MAYOR & COUNCIL COMMUNICATION

AGENDA ITEM: Auto Owners Insurance Preliminary and Final PUD Development Plans

Re: Auto Owners Insurance Building
Plan Review

Grading, Drainage, and Erosion Control Plan

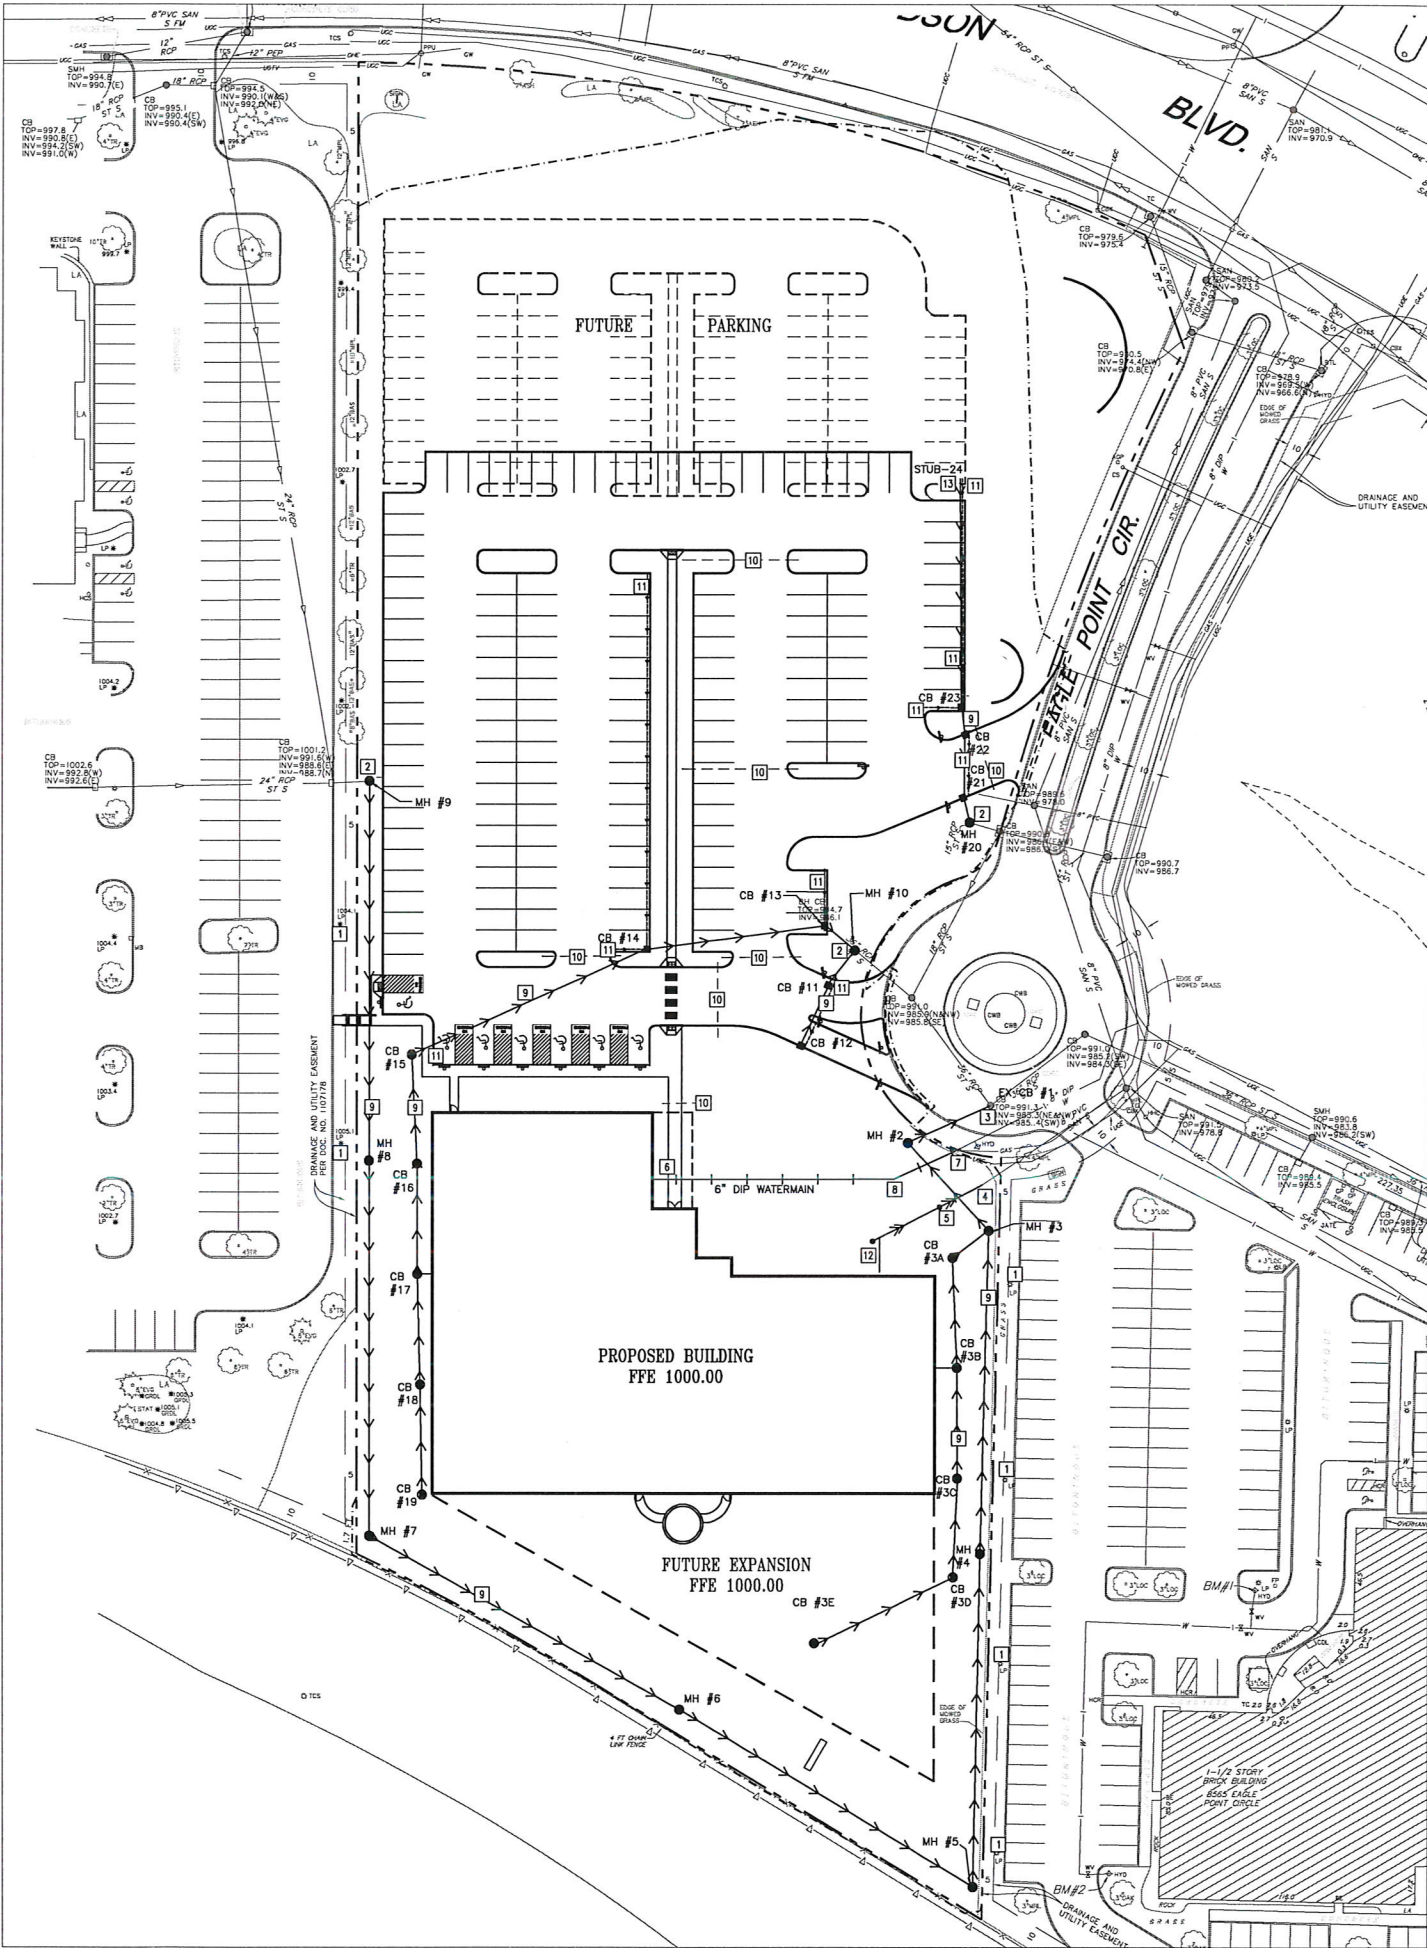
1. City Standard Plan Notes for Grading and Erosion Control must be included on the Grading & Erosion Control Plans.
2. Minor grading revisions are needed to maintain maximum slopes of 4:1 within public R/W (Hudson Boulevard).

Utility
Plan

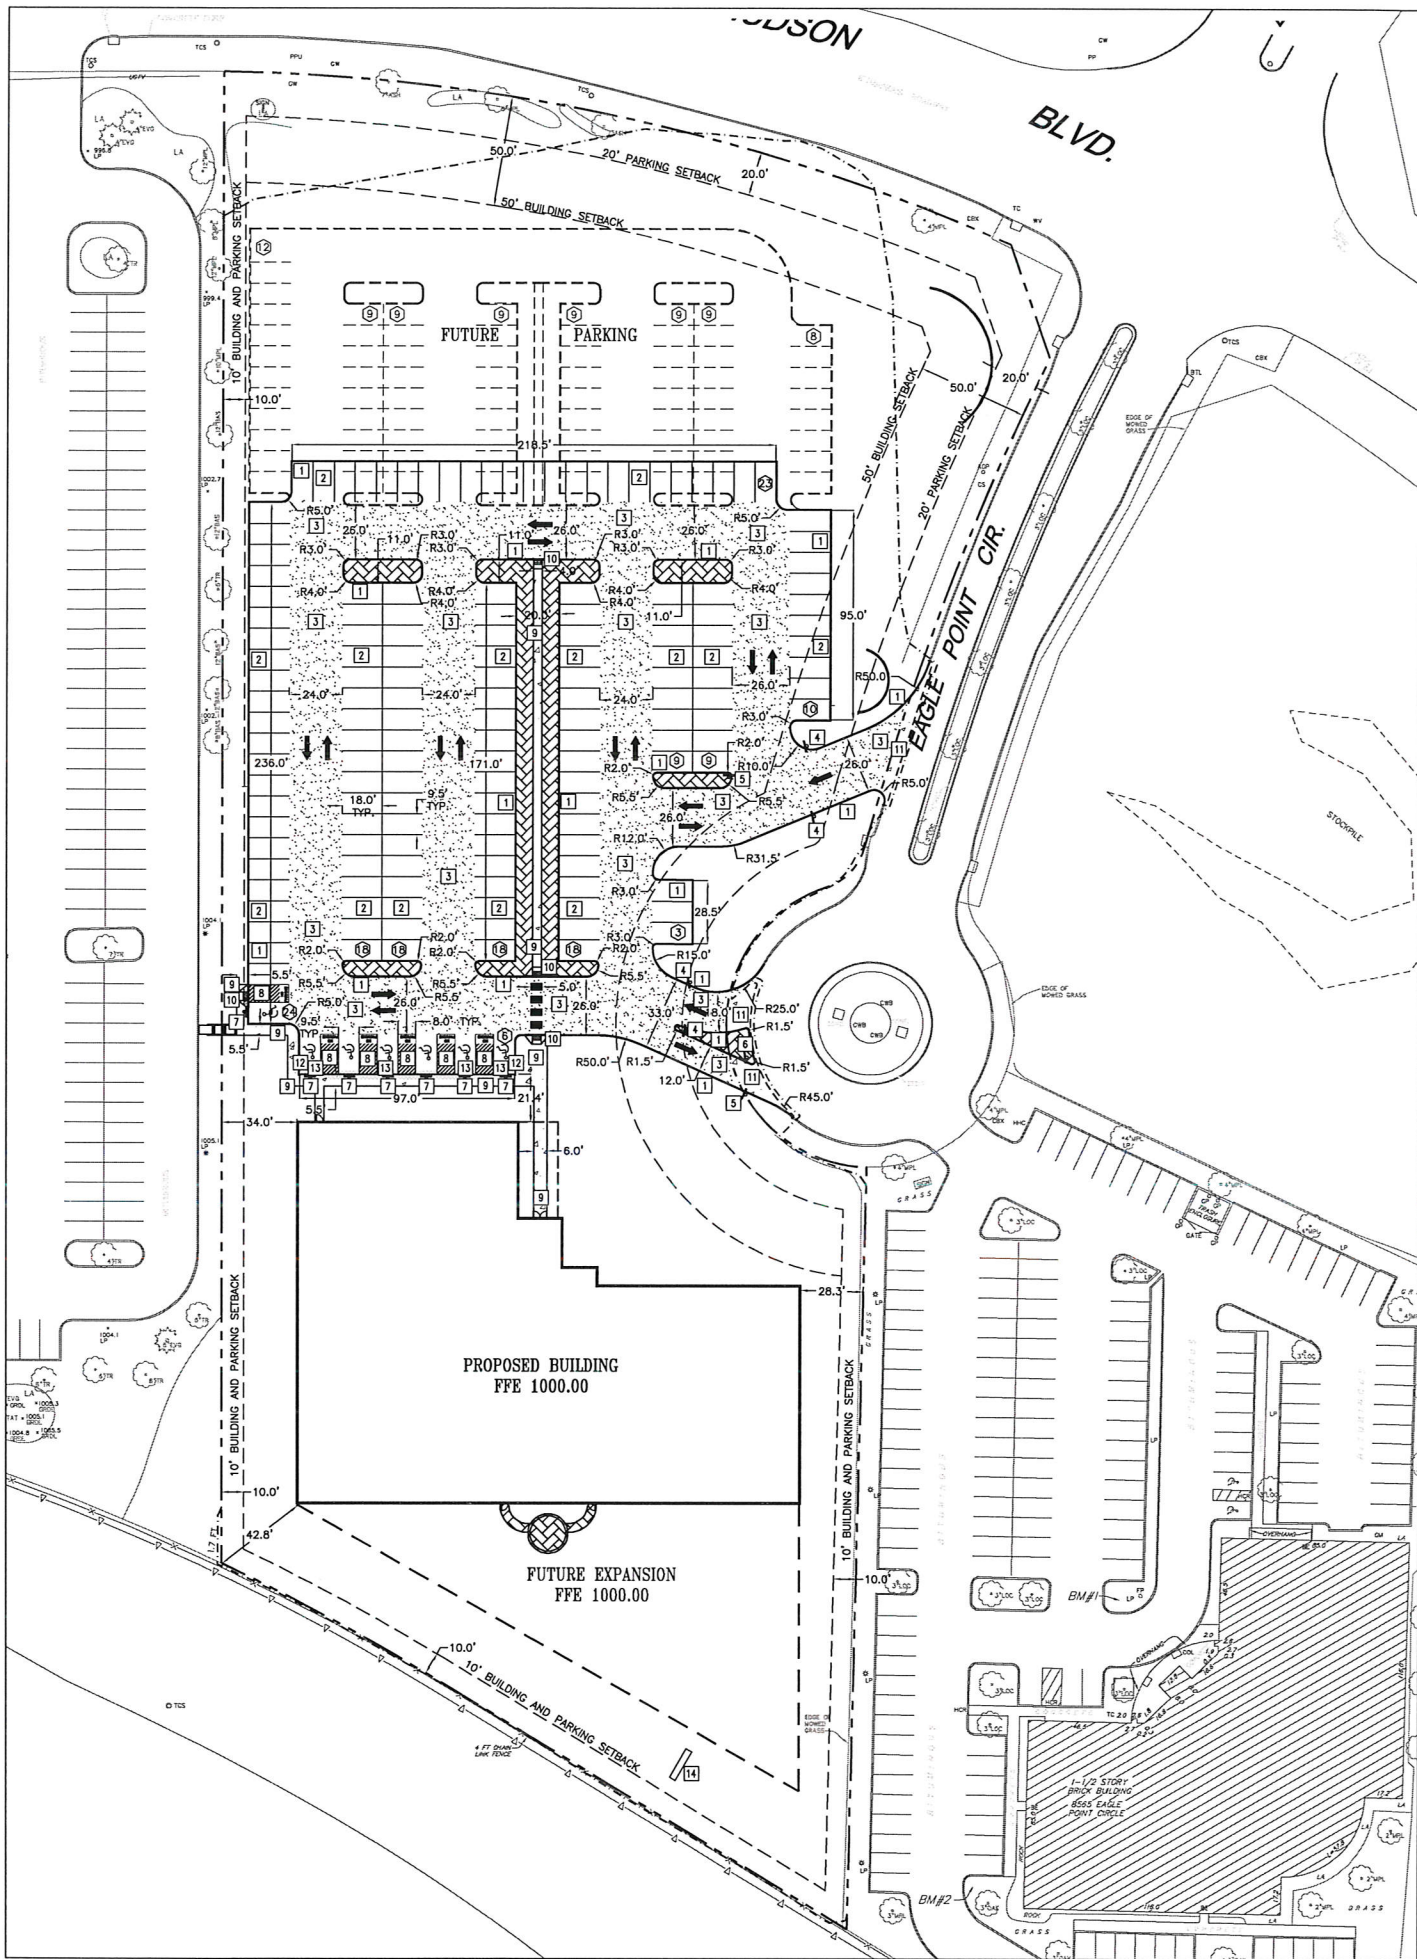
1. Connection to existing sanitary sewer stub. The project proposes to connect to the existing sanitary sewer stub located in Eagle Point Circle.
2. Connection to existing watermain stub. The project proposes to connect to an existing 8-inch watermain located in Eagle Point Circle and extend a 6-inch watermain service to the building.
3. Fire Hydrant locations. No fire hydrants are proposed in the project, however one fire hydrant exists within 65 feet of the proposed building. The hydrant system plan must be reviewed by the Fire Chief. Comments will be forwarded if plan changes are deemed necessary.

NORTH BUILDING ELEVATION

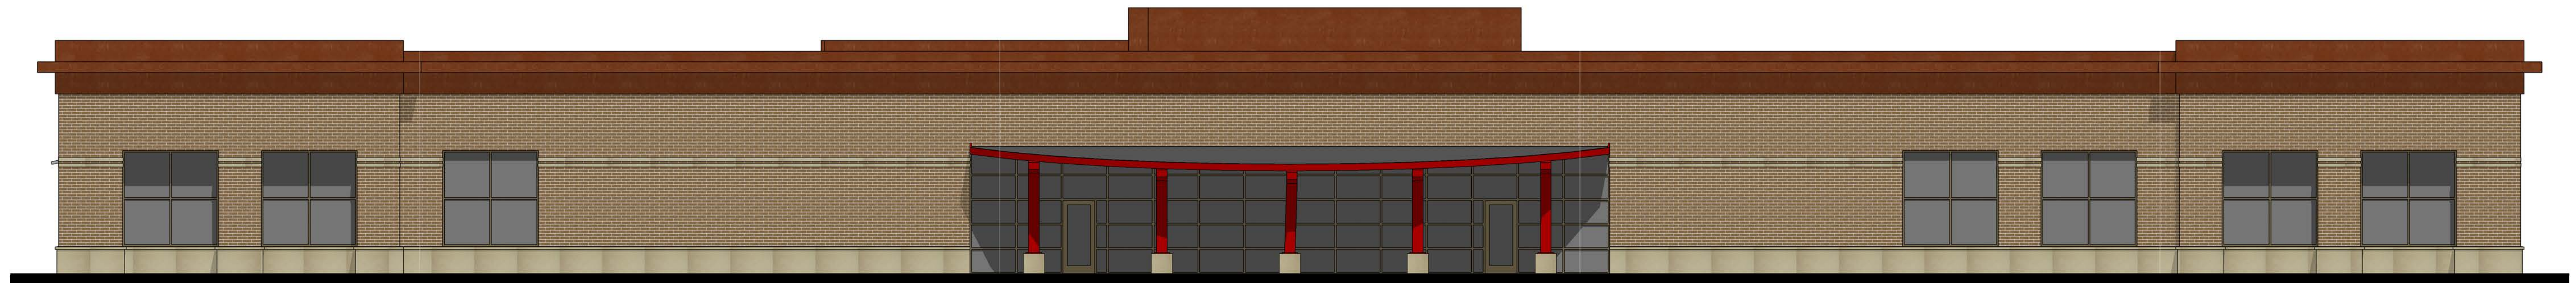
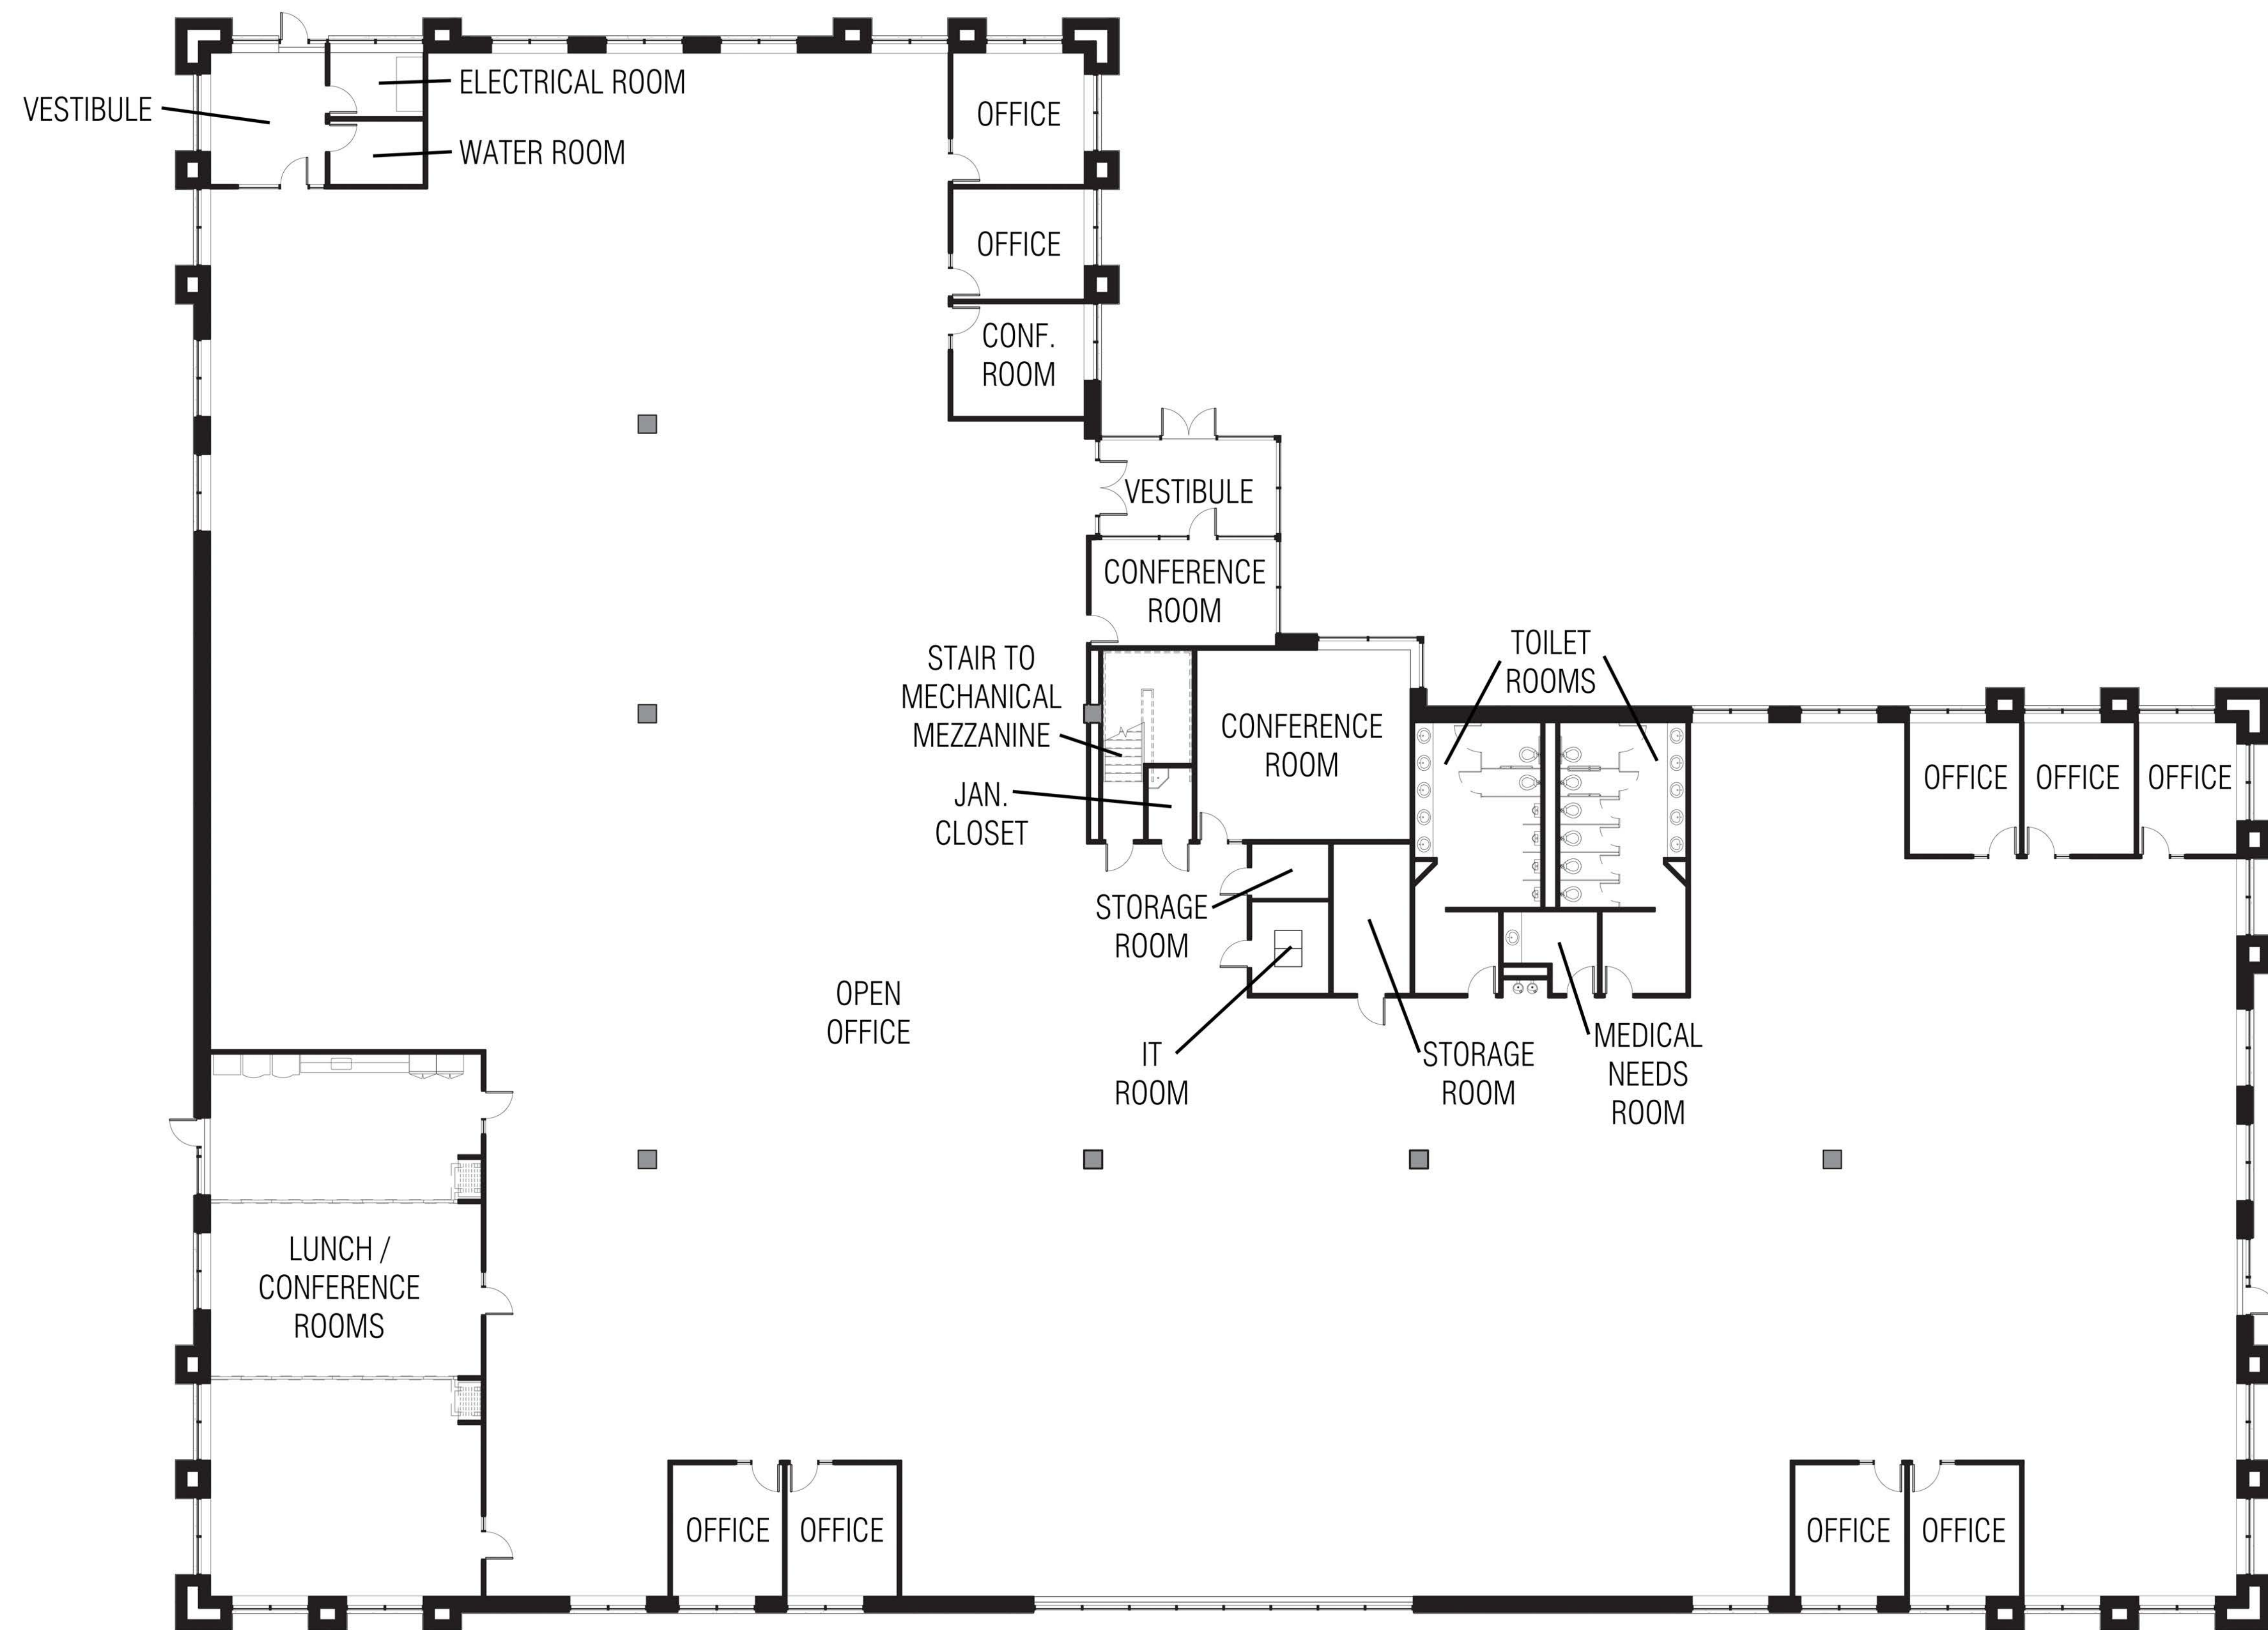
15. Final building plans shall provide additional roof articulation to bring the building further into compliance with the City's design standards.
